STAFF REPORT: OCTOBER 12, 2022 MEETING

APPLICATION NUMBER: 22-8048

ADDRESS: 1515 CHICAGO

SCOPE: REPLACE FRONT PORCH COLUMNS AND REPAIR PORCH FLOOR AND STEPS, ERECT REAR DECK

Left - Original column (3)
 Middle: Replacement column (1)
 Right: Proposed column

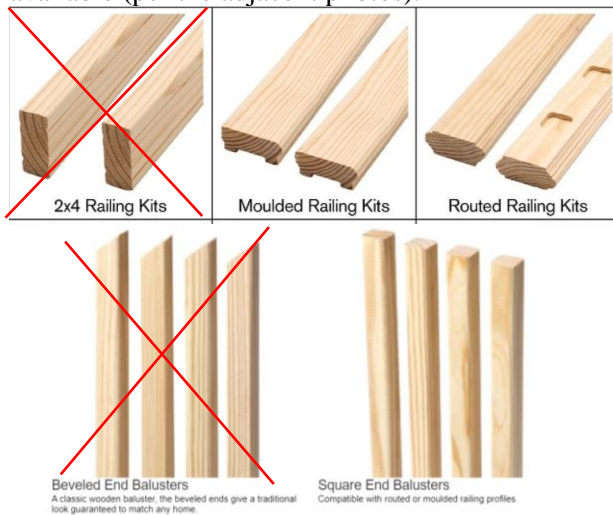
- The design of the proposed new replacement column offers significantly less fluting around the circumference, as well being significantly shorter in length. These reductions create a flatter, more contemporary appearance which is counter to the highly detailed and patterned front elevation. Also, the proposed columns extend to grade, eliminating the need for a pedestal, furthering a more streamlined appearance to the portico.

Staff notes that the three existing and single replacement columns are different dimensions, but the taper is the same 1” from base to top, creating a similar proportion. The new column has a larger base so the taper is closer to 2”.

It is staff's opinion the work as proposed for the portico, consisting of the replacement of the four (4) columns and retaining and repainting the surfaces of the front porch floor and steps will alter the features and spaces that characterize the property. Therefore, staff recommends the Commission issue a Denial for the work as proposed because it does not meet the Secretary of the Interior Standards for Rehabilitation nor the Boston Edison Historic District Elements of Design, specifically Standards:

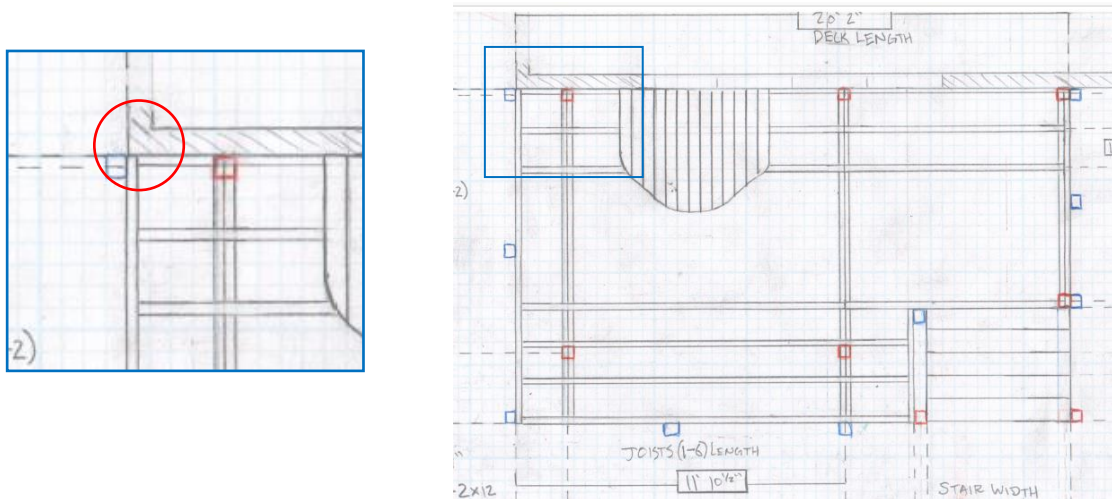
- The selected angled balusters applied to the outer side of the top and bottom rails is a contemporary deck design and is in sharp contrast to the historic dwelling. Installing square end balusters to the underside of the top and bottom rails is similar to the design of a historic railing. Staff researched the manufacturer's railing designs and a more sympathetic baluster and top/bottom rail is available (per the adjacent photos).

- The blue squares denote the supporting deck posts and are placed adjacent the deck edge only for illustration so the location of the porch balusters can be clearly identified. The posts will be installed below the deck floor.
- Staff believes the deck should be inset 3" from the side of the house. This will create a slightly deferential condition for the deck to the house and will eliminate any challenge of lining up the deck wall to the house wall.

- The deck and stair railings will be constructed with the molded or routed railings and square balusters. The final selection will be listed on the deck material list and drawings.
- The deck will be inset from the west wall of the house by 3". The deck plan will be revised, or a note stating this design change will be added to the existing drawings.
- A site plan will be submitted confirming the porch step repair will retain the existing footprint and radius, along with the dimensions for the new concrete front walkway steps.
- Repaint painted porch elements in off-white colors to match historic conditions. Paint samples will be submitted to staff for field verification for approval prior to application.

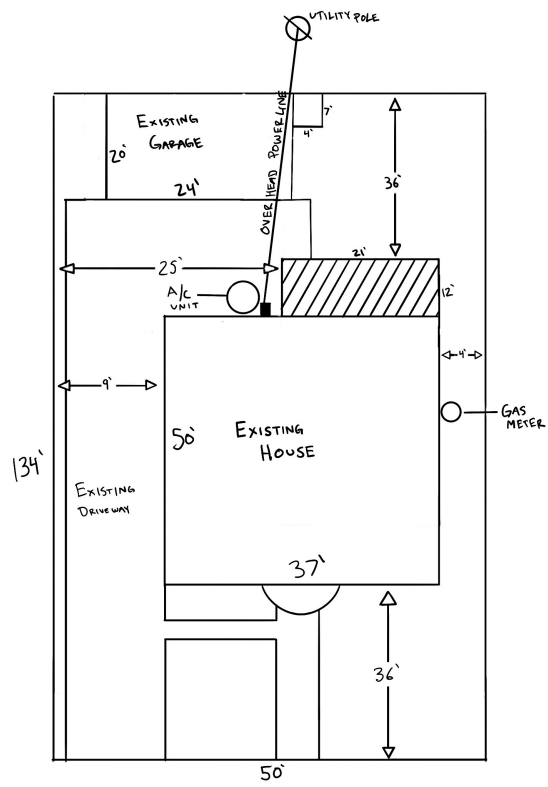
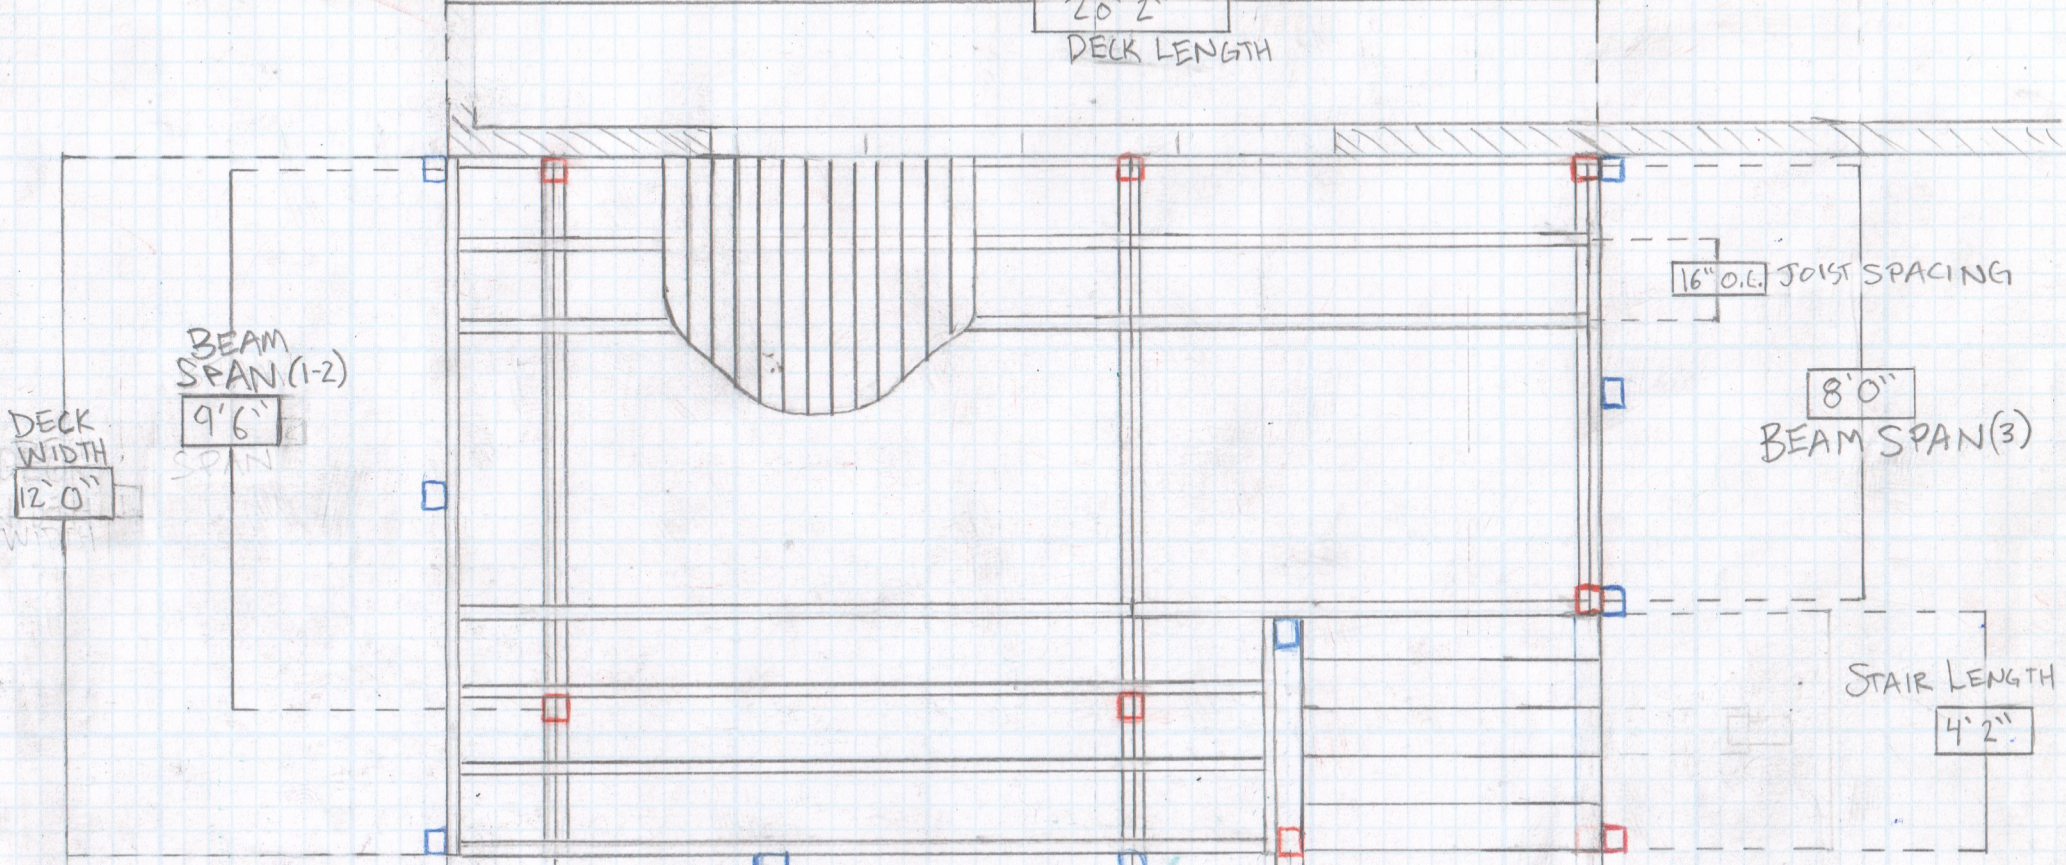
In my deeper review of the house, I noticed work done in the recent past that was not reviewed/approved by the Commission, which includes the painting of the porch floor and steps, porch face brick and column pedestals. These painted elements are a violation. Below left is a 2009 Google image (the 2011 Google image shows the porch elements painted) and the 1974 designation photo more clearly shows the original materials' finishes. I would like to know if you want to add these violations to the application, asking that they remain as-is, or if the property owner would like to remedy the unapproved work, as this would affect your current scope of work. Also, do you have a more

I was unaware of the changes that were made to the porch, they must have been made by the previous owner after the 2011 photo you sent me. I guess I would ask to allow us to keep that part of violated repairs to the porch as is because I do not think we would be able to remove that concrete without damaging the bricks underneath. If that were the case, we would be open to painting the porch the same color brown that is on it now, or we could also try to power wash back down to the concrete finish first if they would rather us try that? We would also like to keep the column and roof portion of the porch the same almond color that is on it now, from the looks of the 2010 photo I believe it was already switched to that color by a previous owner as well.

For the columns, I have sent close ups showing the extent of the damage/poor repair of damage to the columns so I don't have anything else to share on that front. But that really isn't the reason we are asking to replace all four. We could repair the three original columns, but then we would still have a fourth column that does not match so it wouldn't really solve the issue in our opinion. From my understanding of the research our assistant did, our first plan was to have a replica of the three original columns made to replace the mismatched fourth column with. Unfortunately she was not able to find a company that made custom designed columns, all of the companies she was able to find only made select styles, none of which were a close enough match to the originals. This is why we asked to replace all four columns to create a matching set of four columns. It is also my understanding that she could not find columns in the exact height of our existing columns in order to save the pedestal boxes. If we were to somehow find columns that allowed us to rebuild the wooden box pedestals, would it help us to get approval for replacing all four? As I mentioned in my previous emails, we are also open to having the fourth column replaced with an exact replica of the original three if we could be provided with a referral to a company that can provide that service, as that would be the easiest and best solution. Let me know if there is anything else I can help with!
